Proposed Change to Pilgrim's Technical Specification Concerning  
the Safety Limit Minimum Critical Power Ratio (TAC # ME0241)

LETTER NUMBER: 2.09.006

PILGRIM RESPONSE TO REQUEST FOR ADDITIONAL INFORMATION (RAI)  
RELATED TO CYCLE 18 SLMCPR TECHNICAL SPECIFICATION (TS) CHANGE FOR  
PILGRIM NUCLEAR POWER STATION (PILGRIM)  
(TAC # ME0241)

**FIGURE 2**  
**PILGRIM POWER / FLOW MAP**  
 Scram and Rod Block Data based on Nominal Trip Setpoints  
 CORE FLOW, MLB/HR

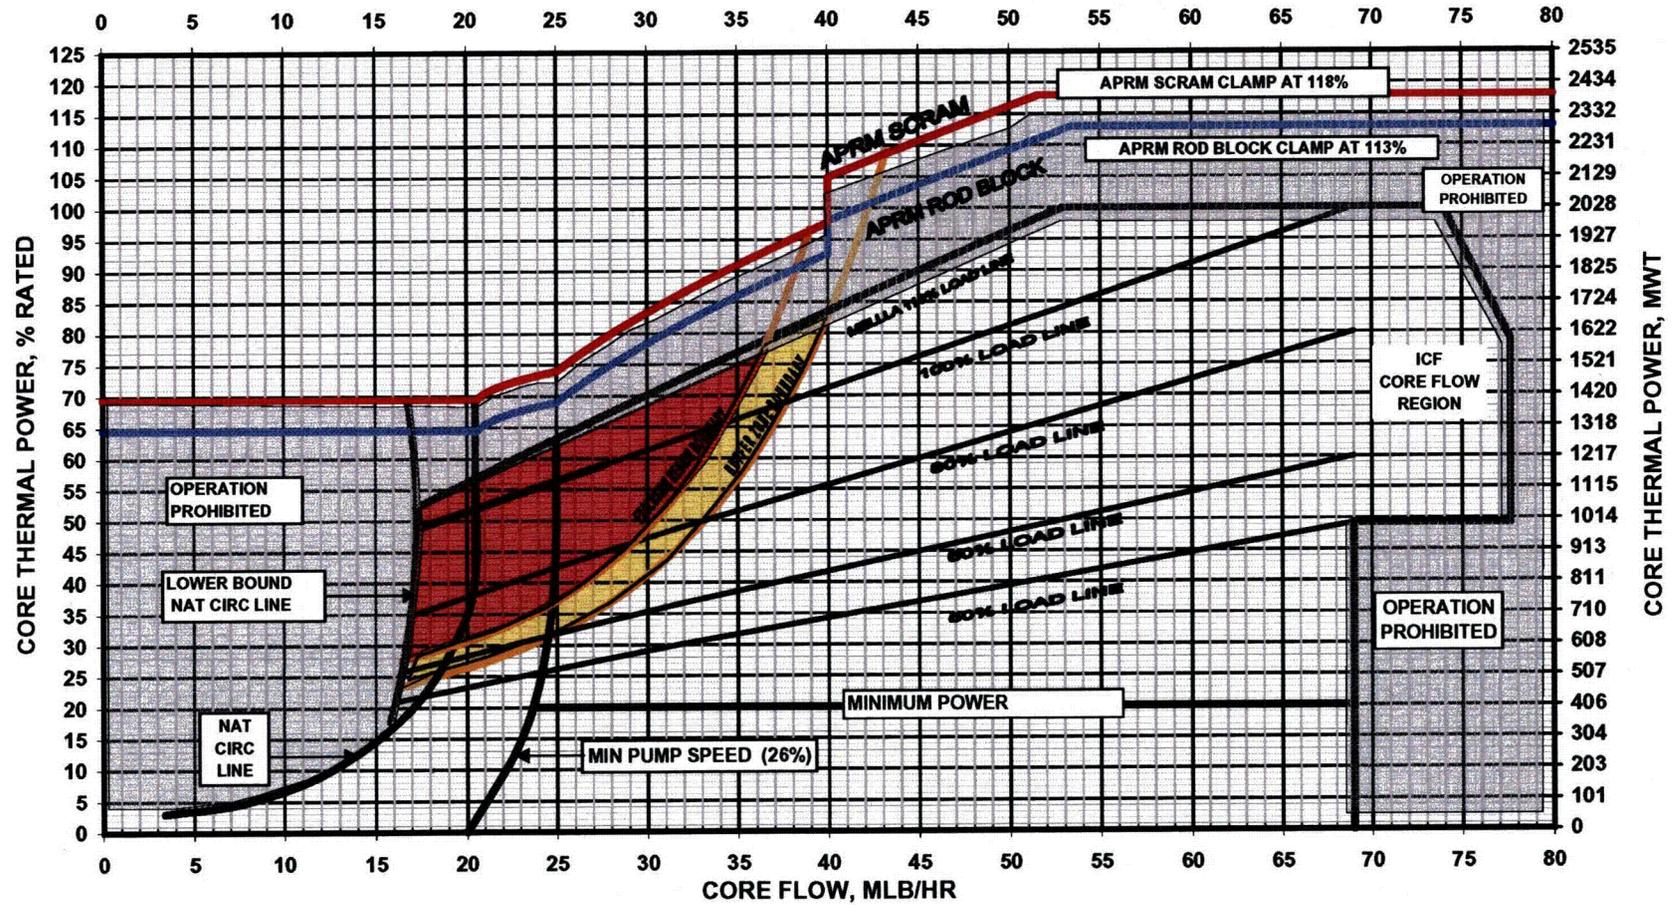
Provide the currently approved Power/Flow map for Pilgrim. If Pilgrim was authorized to operate in the Maximum Extended Load Line Limit Analysis (MELLLA) domain, please indicate for how long the plant has been operating with MELLLA.

Pilgrim Power-Flow Maps for Cycle 17 for Two Loop (Figure 2) and Single Loop (Figure 4) Operations are enclosed. PNPS has had MELLLA beginning with Cycle 11, which began on 6/7/1995. The MELLLA Analysis report is NEDC-32306P dated March 1994. MELLLA was implemented using 10 CFR 50.59.
